Design Review Board Agenda

**CITY OF MILL CREEK
DESIGN REVIEW BOARD
APPLICATION PL2018-0001**

NAME OF PROJECT: Murphy's Corner Starbucks

**CITY OF MILL CREEK
DESIGN REVIEW BOARD
APPLICATION PL2017-0033**

Attachment 2 – Exterior Elevations (Sheets A-2002 and A-2003)

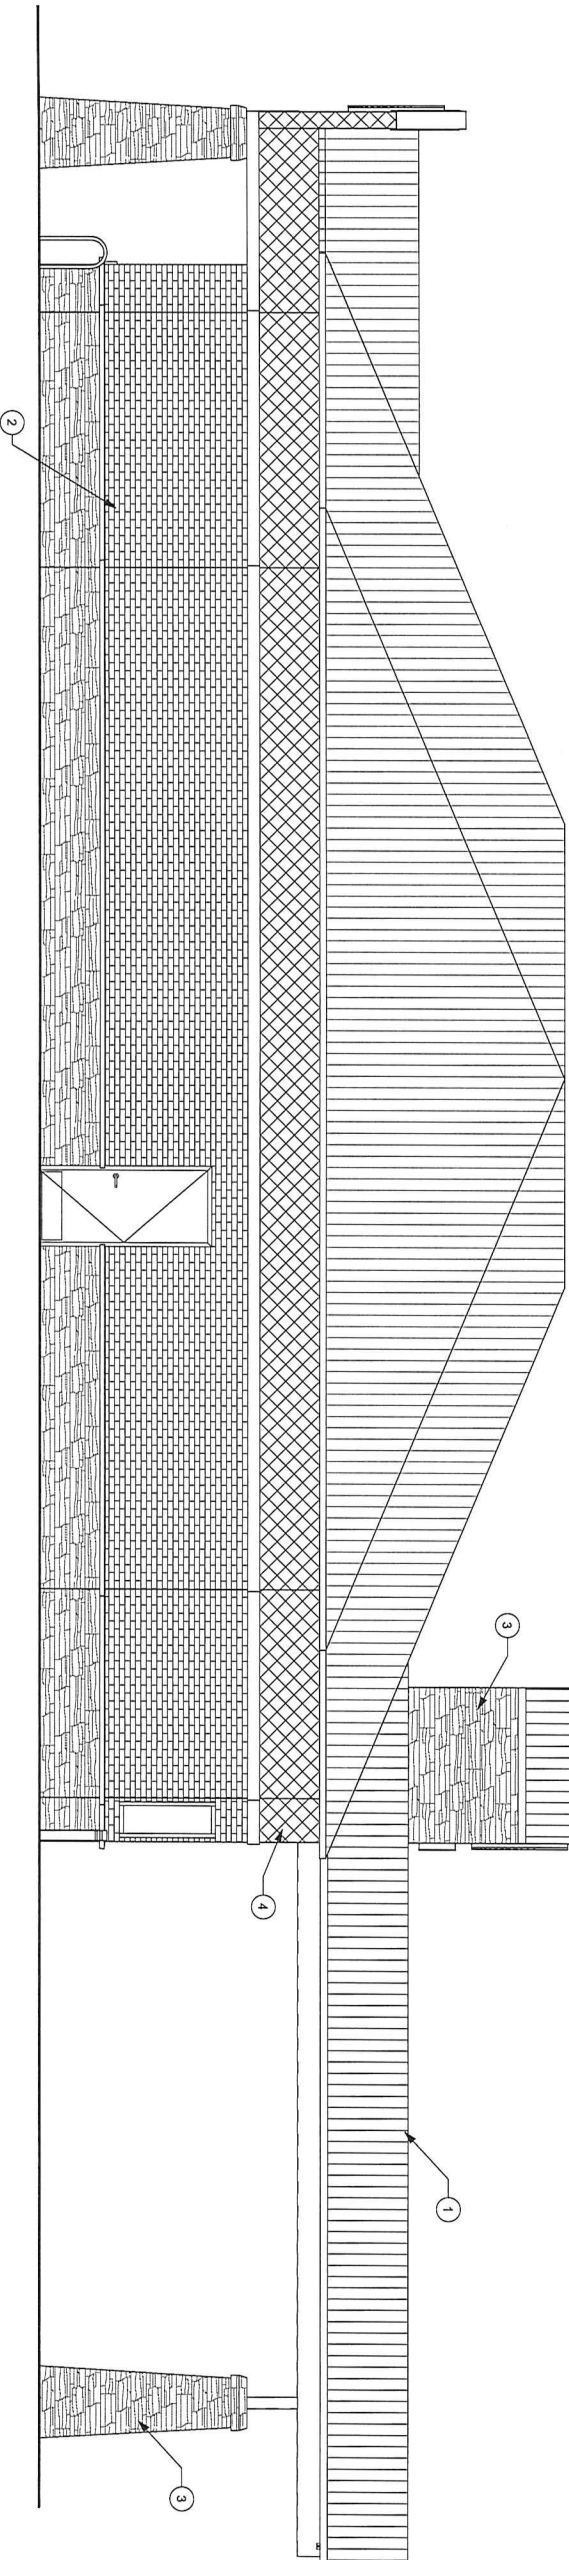
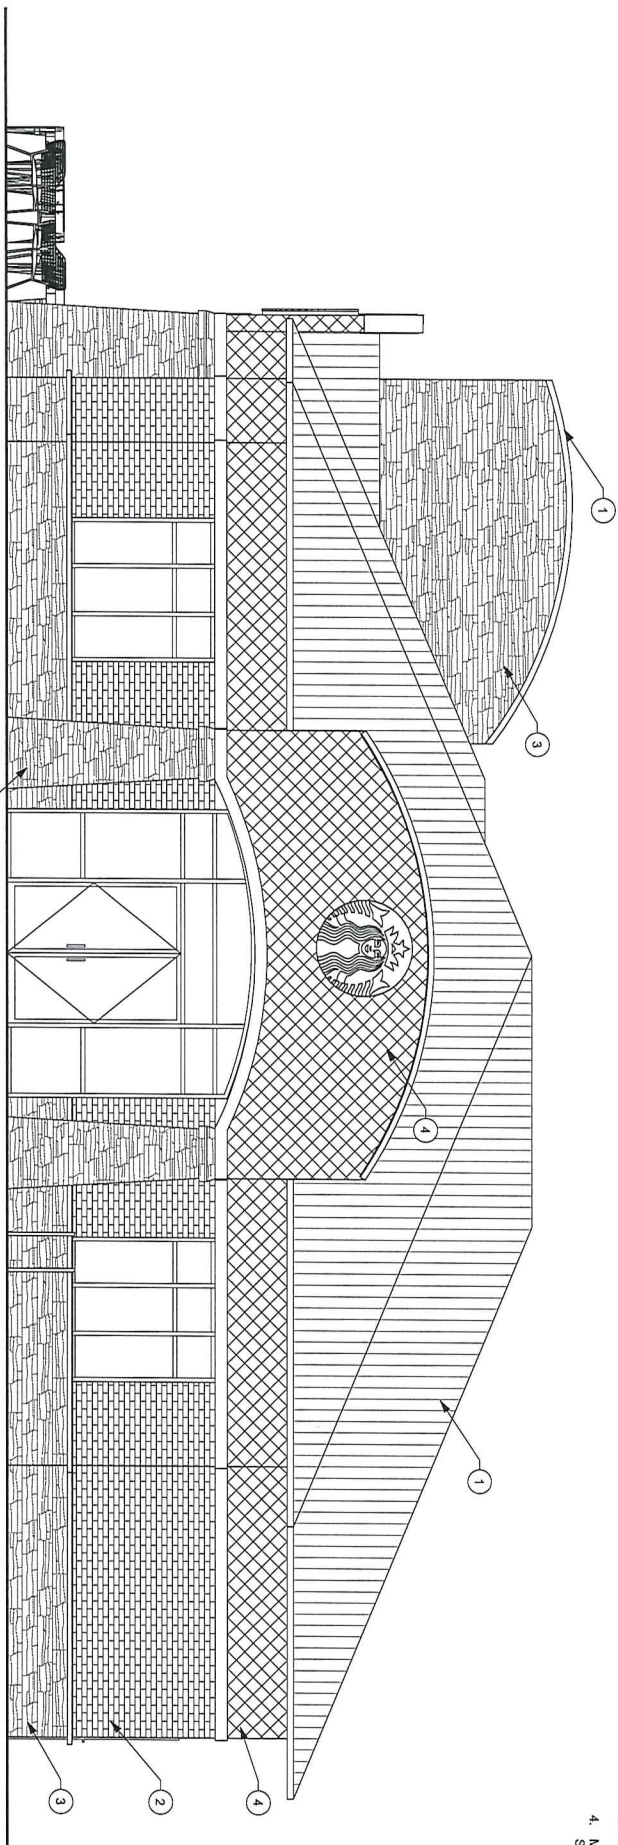
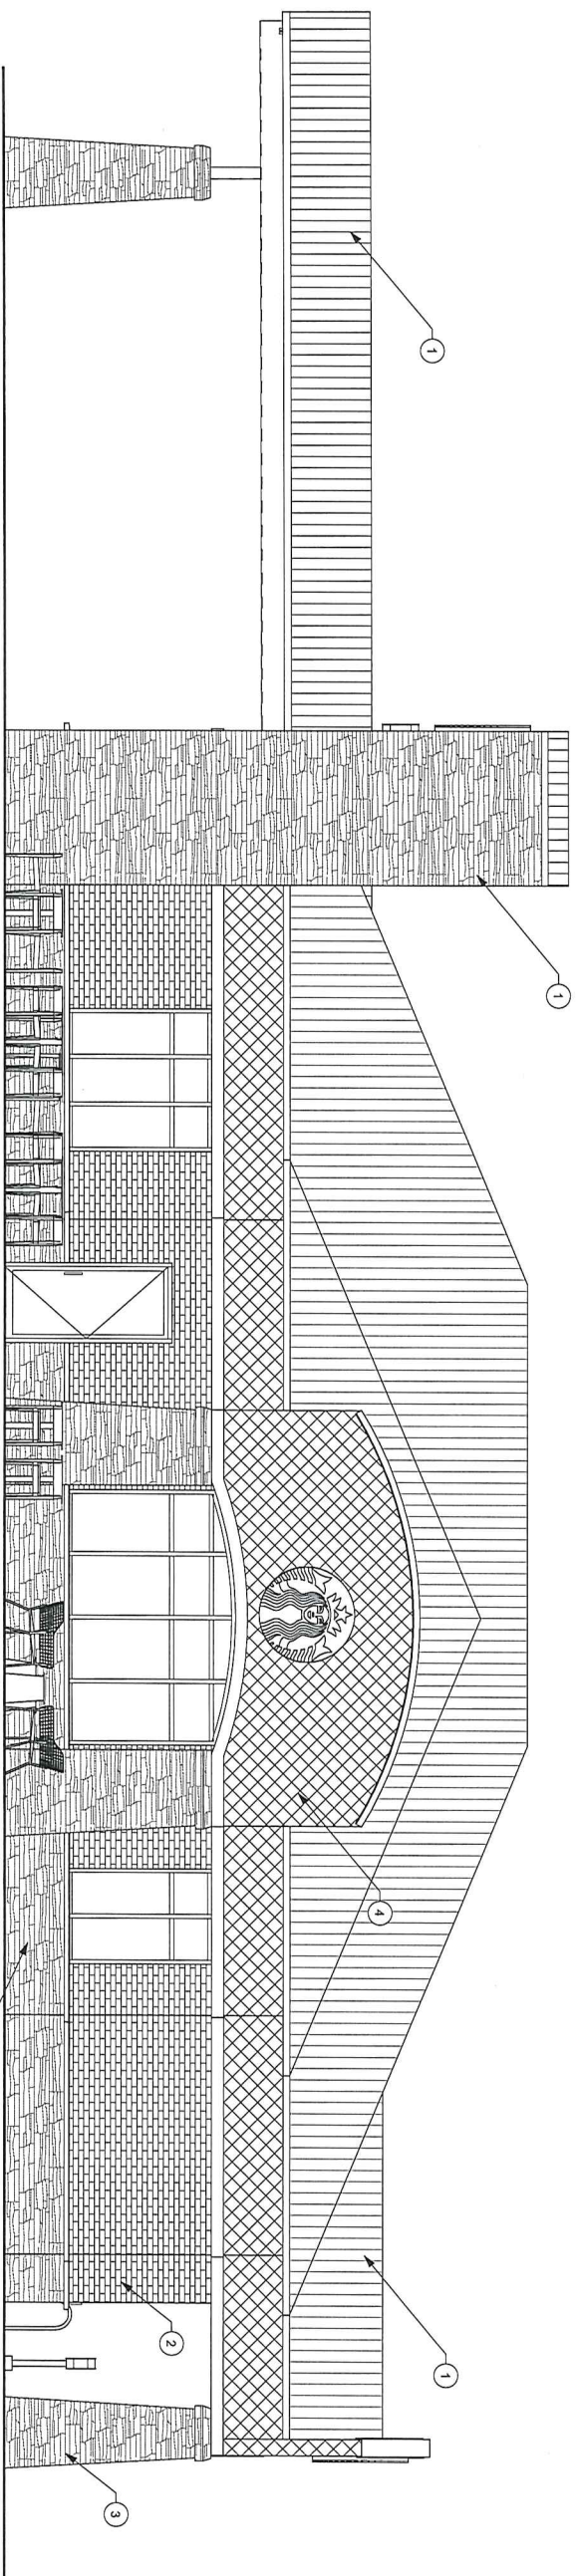
Changes to the building are primarily cosmetic. The roof, canopy, walls and brick will be painted in a darker color palette – Sherwin-Williams Iron Ore. The existing stone façade will remain the current color which is a medium gray (Eldorado Stone “Prescot”). Minor changes to the building elevations include changes to the drive-thru window to match the Starbucks standard and adding a secondary exit door on the western elevation. In addition to providing a secondary access, this door will also provide access to outdoor seating. Please refer to **Attachment 2 – Exterior Elevations, Attachment 3 – Color Elevations** for additional details.

Not all of the design guidelines related to the building elevations are applicable, such as the requirements regarding modulation, blank walls and building materials, since the building is existing and was previously approved by the Design Review Board and considered to be consistent with the City's design guidelines. The guidelines regarding building colors, however, are applicable and require that the building colors accent, blend with, or complement surroundings. Bright or brilliant colors should be reserved for trim and accents. The proposed color palette meets these requirements. The applicant will provide color samples at the meeting.

As proposed, staff believes that the building elevations are in compliance with the design guidelines contained in the Code.

1. The building elevations, materials, colors, and design shall be as portrayed in the application.
2. Refresh the existing landscaping by weeding and replacing any shrubs that have failed. If any shrubs need to be removed to replace the air conditioning units, replant shrubs that will adequately screen the new utilities.
3. Provide irrigation for the new landscape area in accordance with MCMC 17.34.040.H.1.d

Attachment 4 – Trash Enclosure (Sheet A-1005)

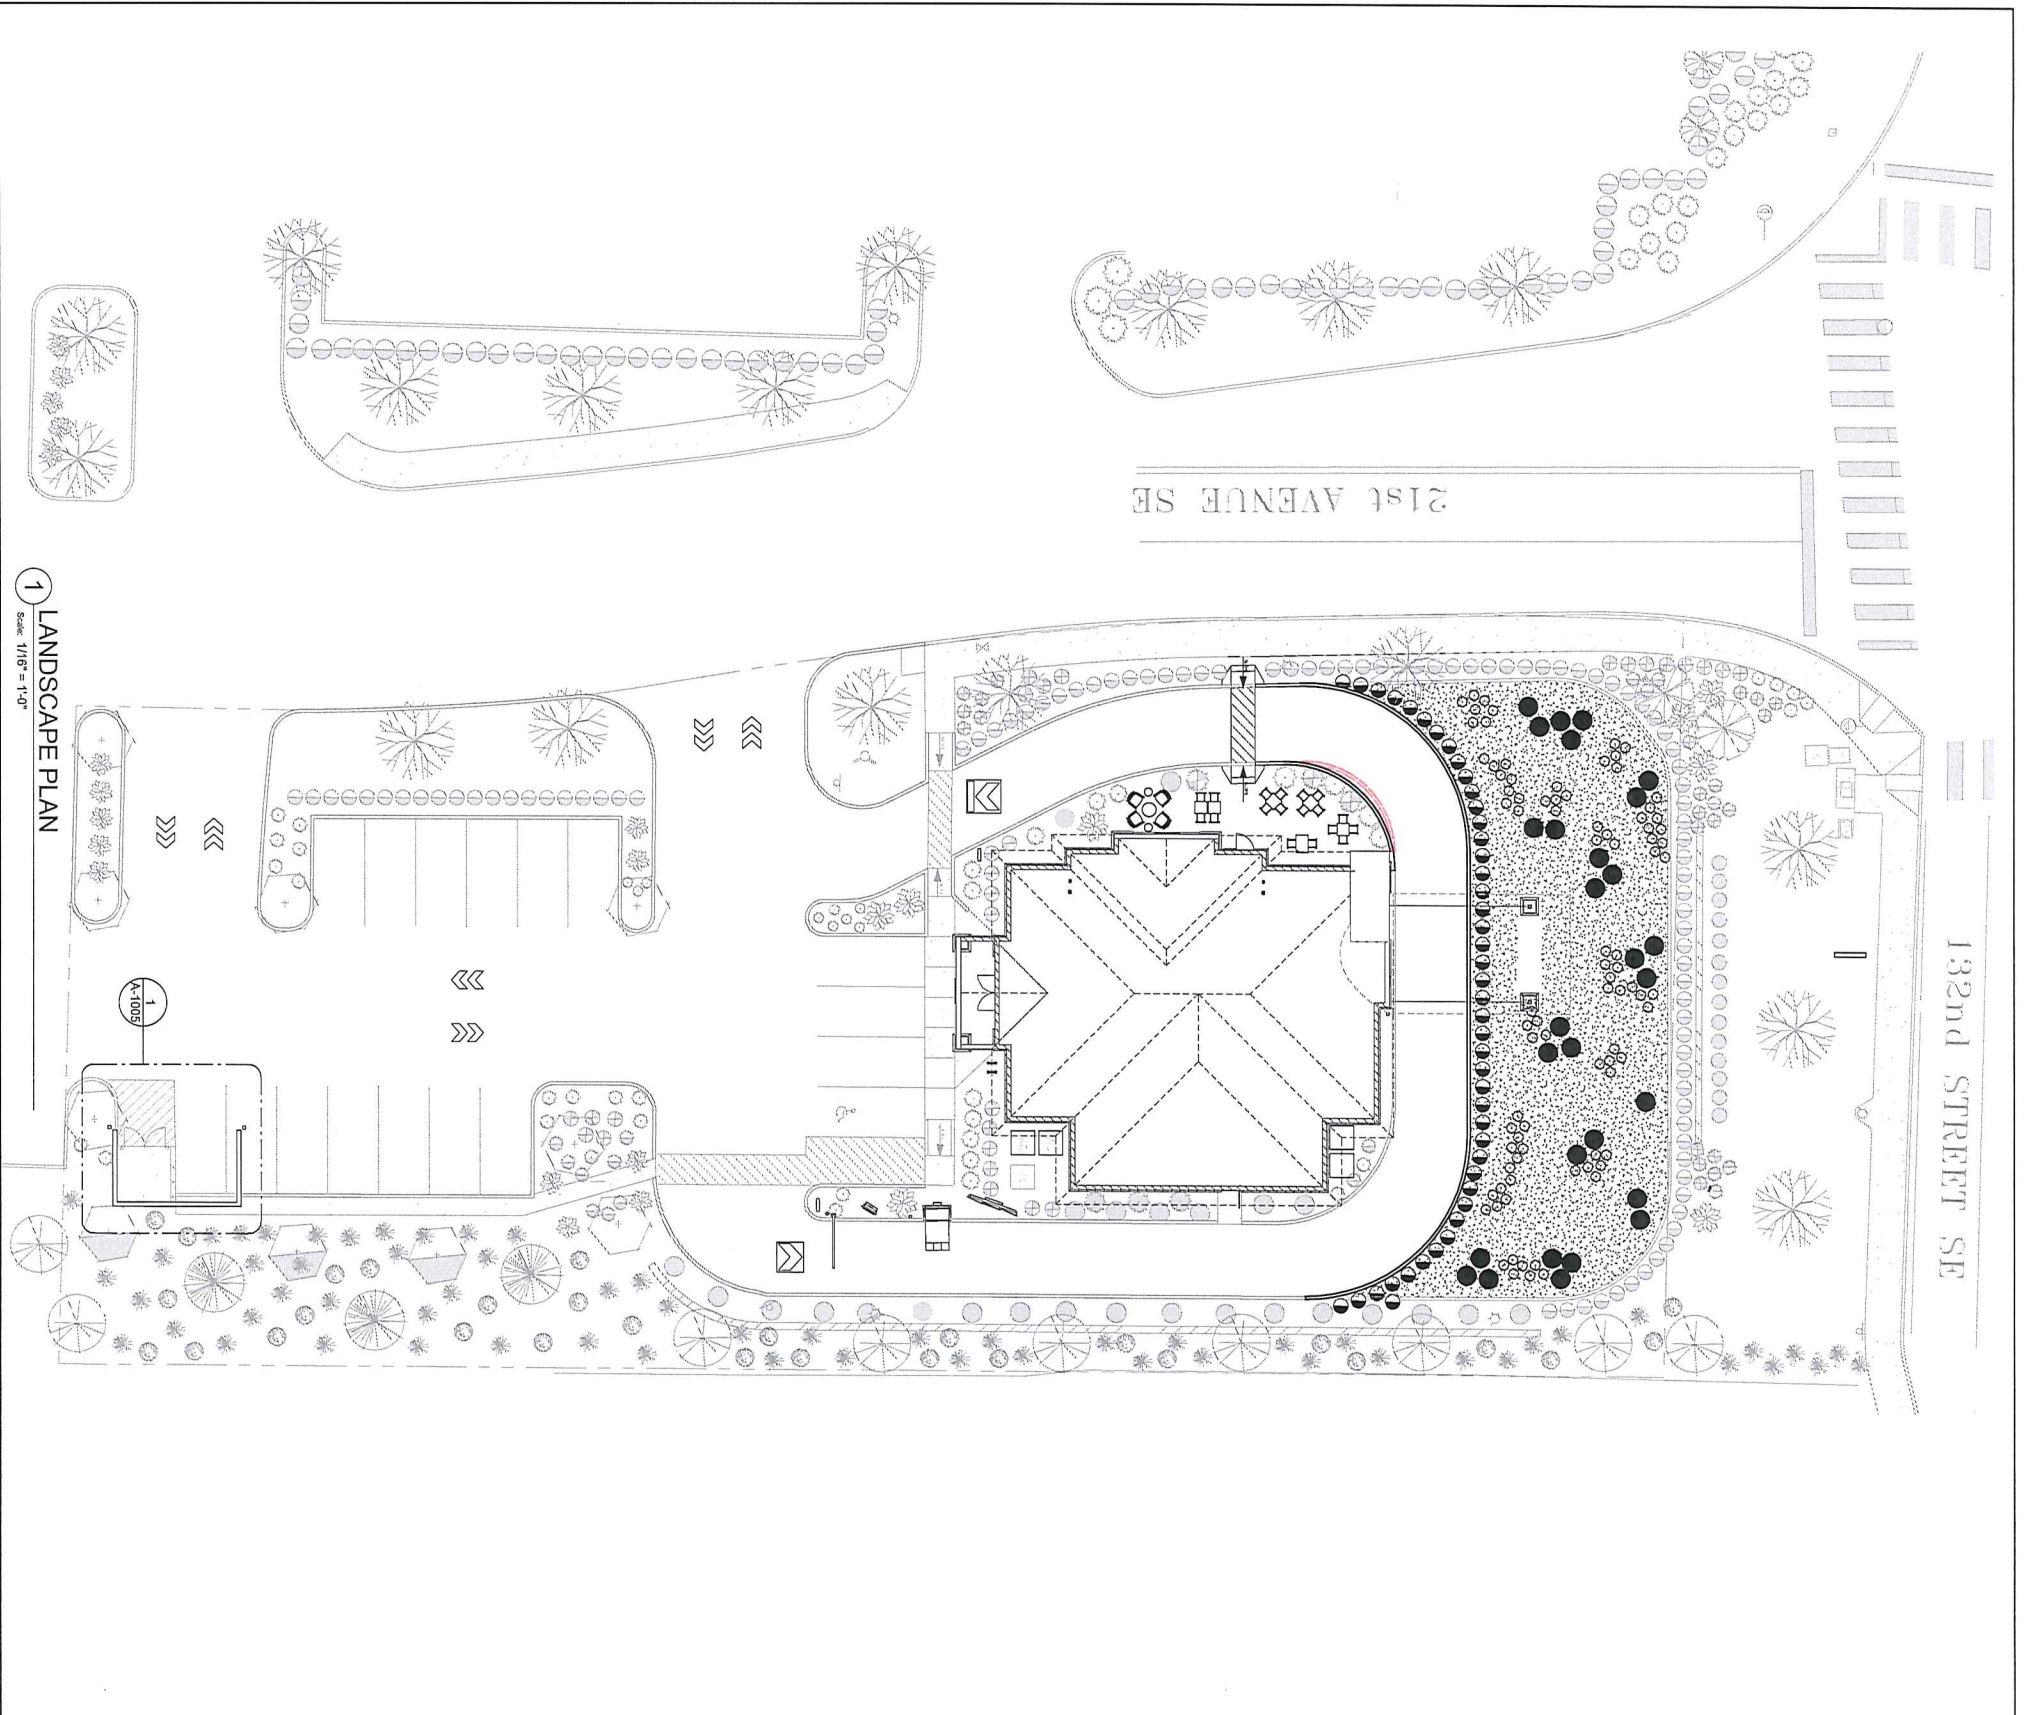
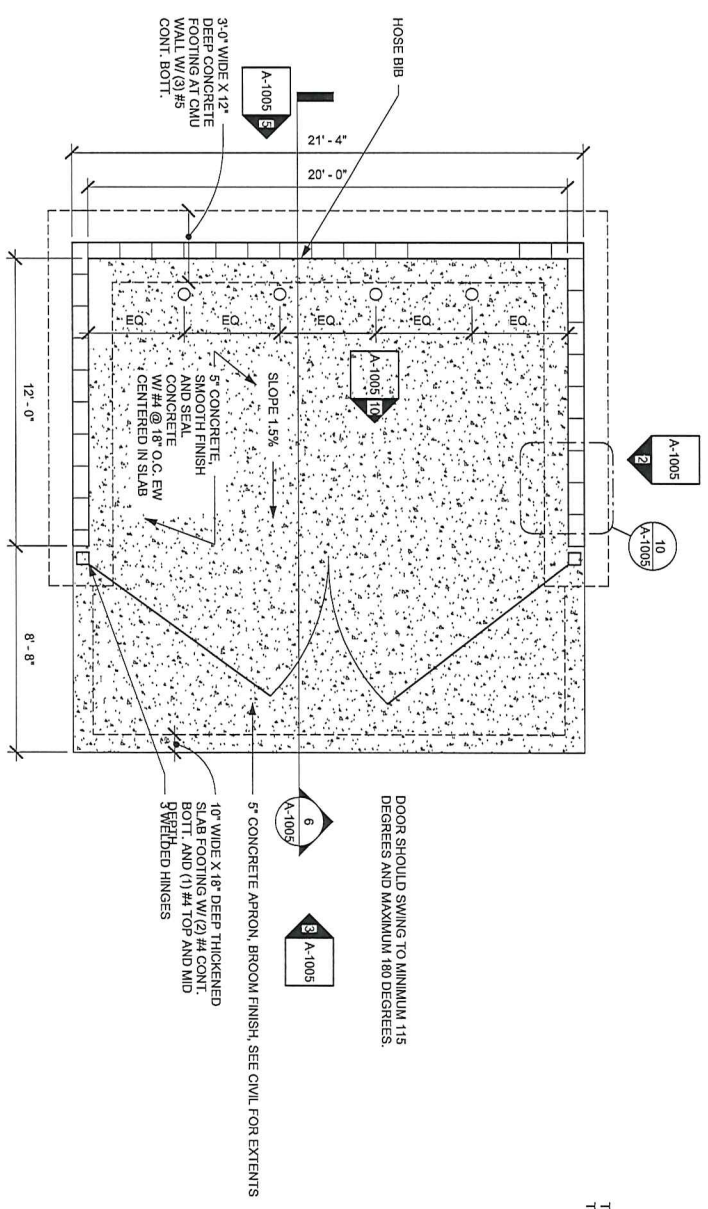
The dumpster area is proposed to be enlarged to accommodate two dumpsters, which will result in the loss of one parking space. Even with the loss of one space, adequate parking is proposed. A total of 13 spaces are required and 14 spaces are provided. In addition, the adjoining Lowe's parking lot has ample room for any occasional overflow parking. Please refer to **Attachment 4 – Trash Enclosure** for additional details.
